## Airworthiness Directive

**AD No.:** 2018-0081

SZD-55-1 sailplanes

## ATA 27 – Flight Controls – Elevator Control System / Vertical Tail – Inspection

Drawing 1

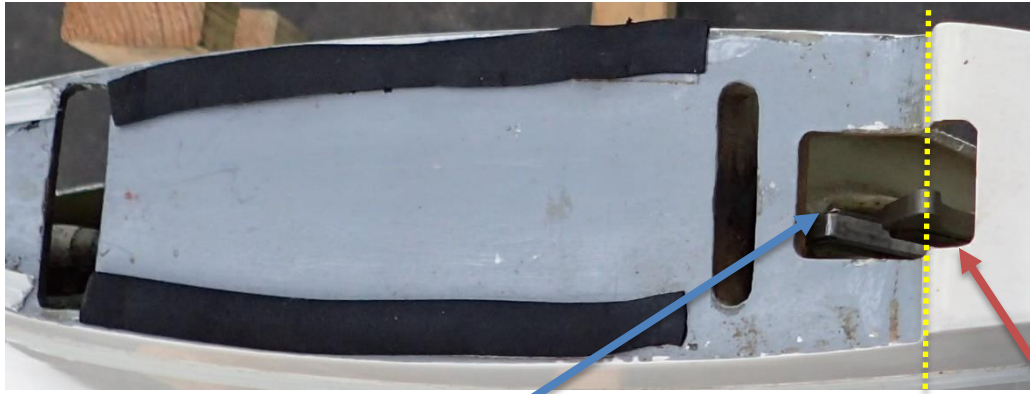
Following a fatal accident with an SZD-55-1 sailplane, it was found that, during rigging, the elevator lever had not been connected with the guide of the control system. The investigation results also revealed that the opening on top of the vertical tail, through which the elevator control lever is inserted, had been enlarged. The correct dimension of the opening ensures safe rigging and is explicitly defined in the design (see Drawing 1, Appendix 1 of this AD) of the horizontal tail (1), where the connection is such that if the elevator lever (7) is not correctly located inside the guide (8), the tail cannot be secured with bolt (5).

Slot for the elevator lever

Drawing 2

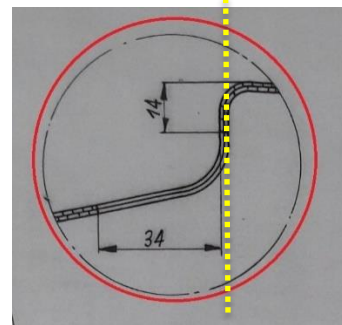
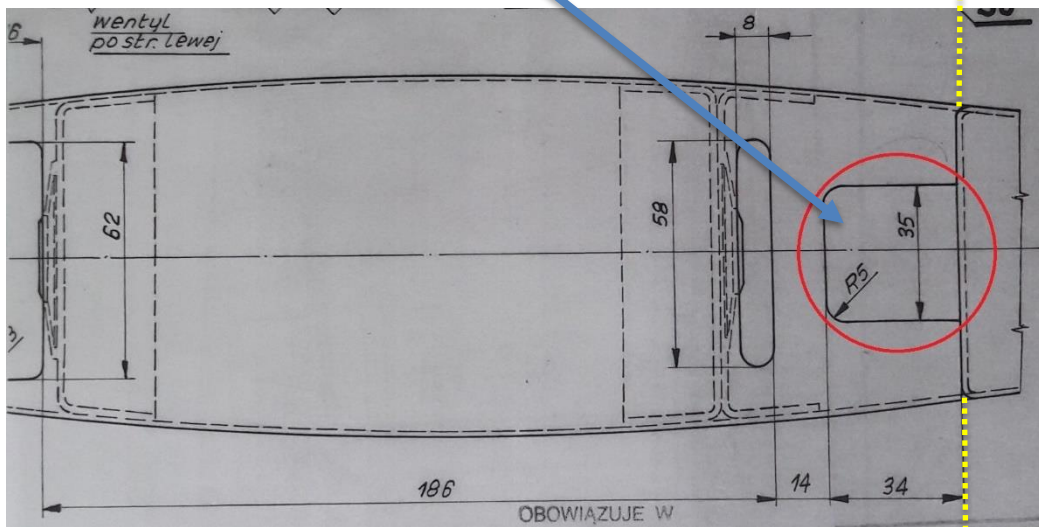
- (1) Within 60 days, or during the next annual inspection, whichever occurs first after the effective date of this AD, visually inspect the size of the opening on top of the vertical tail (see Drawing 2, Appendix 1 of this AD).

Slot extension not as designed

- (2) If, during the inspection as required by paragraph (1) of this AD, discrepancies are detected, before next flight, contact Allstar PZL Glider for approved repair instructions and accomplish those instructions accordingly.
